CITY PLANNING COMMISSION

APPLICATION: Special Permit to develop 54 townhouse units in the Light Density Multiple Family-Review (R-3-R) zone (Section 7-C)

LOCATION: 2360-2400 Northview Drive

EX A

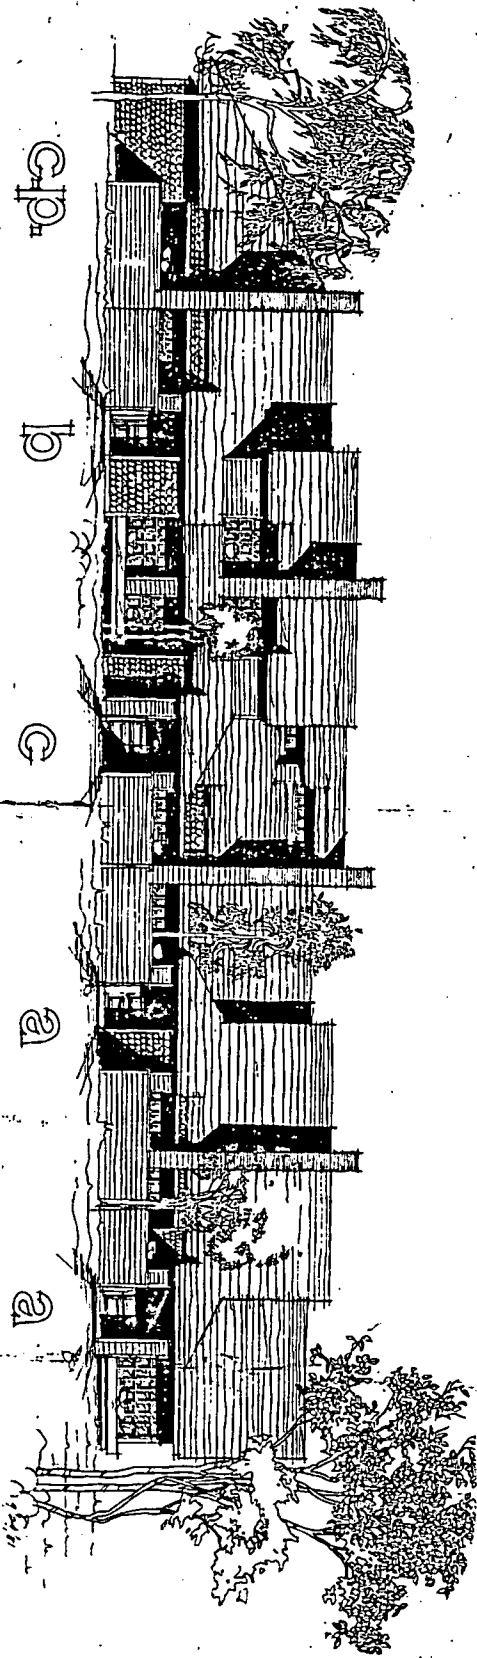
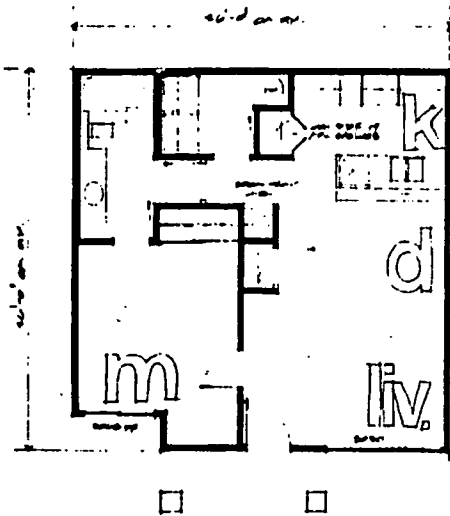
4. The special permit was originally conditioned to require that the proposed driveway entrances be changed to address concerns expressed by the City Traffic Engineer. The Engineer indicated the following modifications would be necessary: a) the north driveway should be a 90° angle and b) the south driveway shall be a minimum of 24 feet wide and 10 feet away from the south property line (see exhibit A).

5. As proposed, the site plan indicates that five parking spaces are to be located in the 25' front landscaped setback area. In addition, the applicant has used parallel parking on the site. These spaces shall be removed and replaced with landscaping since they do not comply with the Zoning Ordinance (Section 6-C-1(a) and Section 6-D-13).

2. The applicant shall redesign the driveway entrances to the satisfaction of the City Traffic Engineer.
3. All parallel parking spaces and those spaces located within the 25' front setback area shall be removed and replaced with landscaping.
